EPC STORMWATER REVIEW COMMENTS
IN ORANGE BOXES WITH BLACK TEXT

Preliminary Drainage Report

Overlook at Homestead Subdivision El Paso County, Colorado

PCD Filing No.: **SP238**

OVERLOOK FILING NO. 1
 EL PASO COUNTY, COLORADO
 PRELIMINARY DESIGN PLANS
EXCLUSION EXHIBIT DRAINAGE MAP

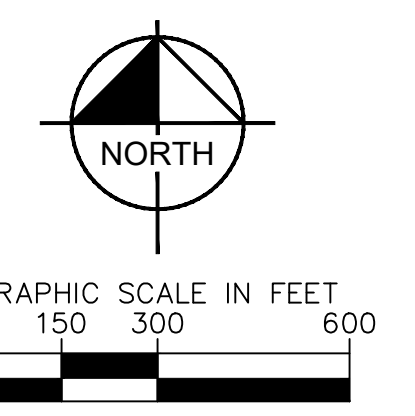
Please add the exclusion number for this (ECM App I.7.1.C.1)

Exclusion number added to table.
